**ADDENDUM
NO. 1**

**SCHOOL CITY OF HAMMOND - ROOFING, HVAC, AND
ELECTRICAL PROJECT
Hammond, IN 46320**

ADDENDUM NO. 1

PREPARED BY SCHMIDT ASSOCIATES FOR:
SCOTT MIDDLE SCHOOL – ROOFING, HVAC, AND ELECTRICAL PROJECT
HAMMOND, SCHOOL CITY OF

6D PROPOSED ROOF PROFILE - ROOF TYPE 'A'
1 1/2" = 1'-0"

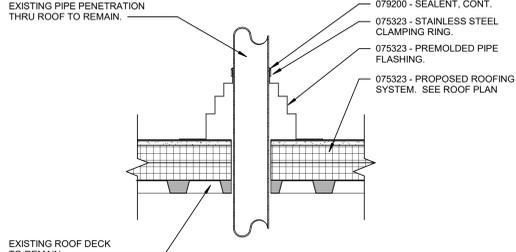
9. The roof area at Morton HS currently has tapered roof insulation on it so it does not match the existing profile on this drawing. It appears that a full tapered system will be required. Existing tapered is extruded with a coverboard mechanically attached to the roof deck.

Response: A revised drawing is included in Addendum #1.

#	Note
1	075323 - PROVIDE NEW ROOFING SYSTEM ON TOP OF THE EXISTING GYPSUM CONCRETE TOPPER SLAB. CONTRACTOR SHALL PROVIDE A PULL TEST TO INSURE PROPER ANCHORAGE OF NEW ROOFING SYSTEM. ROOF PROFILE 'A'. SEE DETAIL 6D/AR301.2
3	EXISTING HVAC EQUIPMENT CURBS/SUPPORT TO REMAIN. CONTRACTOR SHALL FLASH NEW ROOFING SYSTEM PER MANUFACTURER'S RECOMMENDATIONS. PROVIDE NEW TAPERED INSULATION CRICKETS TO DIRECT WATER AROUND EXISTING ROOF EQUIPMENT AND ROOFBUILDING CONDITIONS IN THE FIELD.
4	075323 - FLASH EXISTING PIPE PENETRATION. SEE PIPE PENETRATION FLASHING DETAIL 6C/AR301.2
5	EXISTING ROOF DRAIN TO REMAIN. PREP ROOF DRAIN AND INSTALL NEW ROOFING SYSTEM PER MANUFACTURER'S RECOMMENDATIONS.
6	075323 - PROVIDE NEW TAPERED INSULATION CRICKETS AND SADDLES TO DIRECT WATER TO EXISTING ROOF DRAINS. CONTRACTOR SHALL VERIFY ALL EXISTING ROOF EQUIPMENT AND ROOFBUILDING CONDITIONS IN THE FIELD.
10	EXISTING SKYLIGHT UNIT TO REMAIN. FLASH EXISTING SKYLIGHT CURB PER ROOF MEMBRANE MANUFACTURER'S RECOMMENDATIONS. PROVIDE TAPERED INSULATION CRICKETS TO DIRECT WATER AROUND EXISTING CURB TO DRAIN.
